RE: UM 1910 – PacifiCorp’s Resource Value of Solar – ERRATA FILING

PacifiCorp d/b/a Pacific Power encloses for filing the corrected testimony of Daniel J. MacNeil (PAC/100). For convenience, both a red-line and clean version of the complete testimony are enclosed.

ERRATA
Docket No. UM 1910
Exhibit PAC/100
Witness: Daniel J MacNeil

Direct Testimony of Daniel J. MacNeil

1 **Figure 4: RVOS Avoided Energy Cost for the Indicative Fixed Solar Resource**

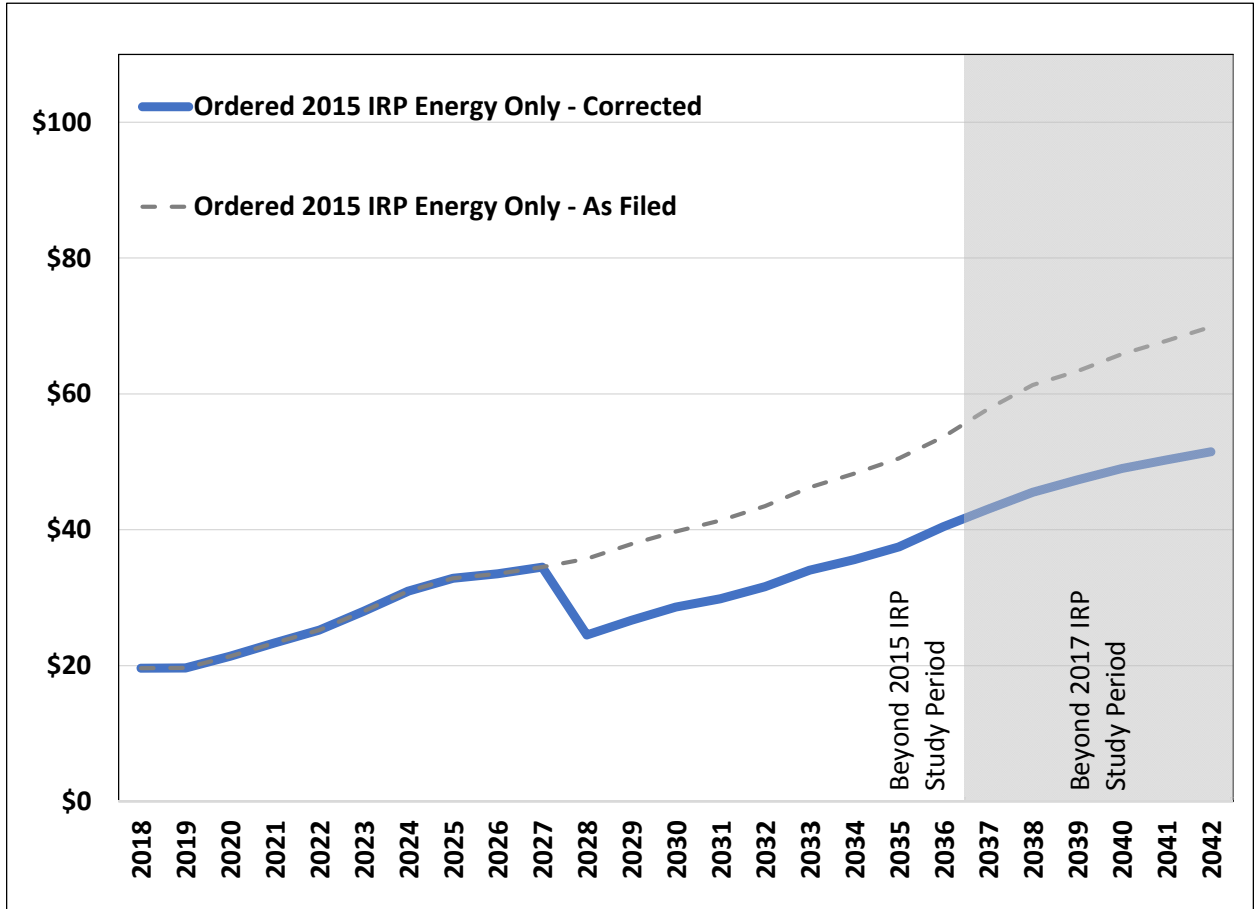
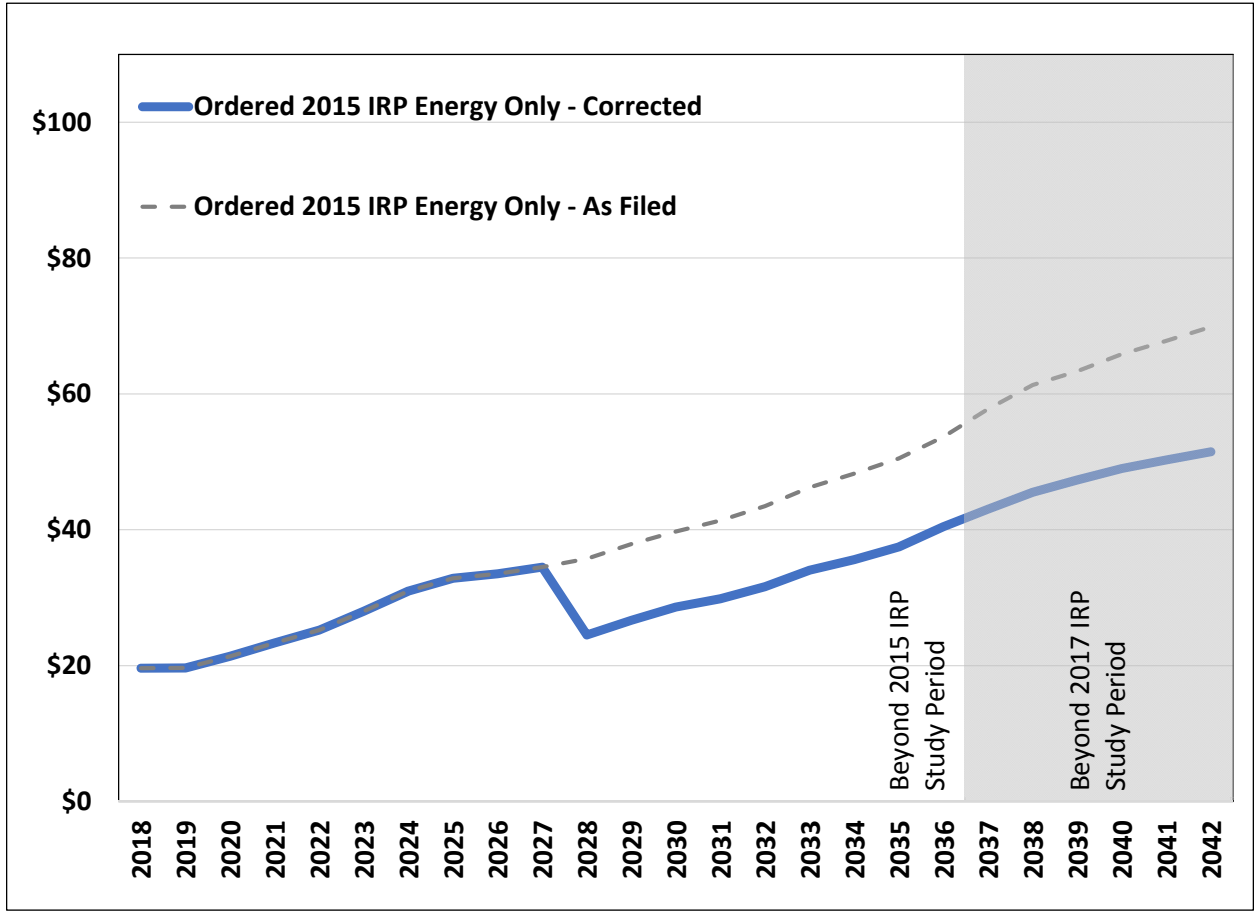
- Page MacNeil/3 – corrected Table 1 – Standard 2015 IRP column
- Page MacNeil/18 – corrected Figure 4
- Page MacNeil/35 – line 13
- Page MacNeil/46 – line 22 through MacNeil/47 – line 10
- Page MacNeil/48 – corrected Figure 5
- Page MacNeil/49 – line 4
- Page MacNeil/49 – corrected Figure 6
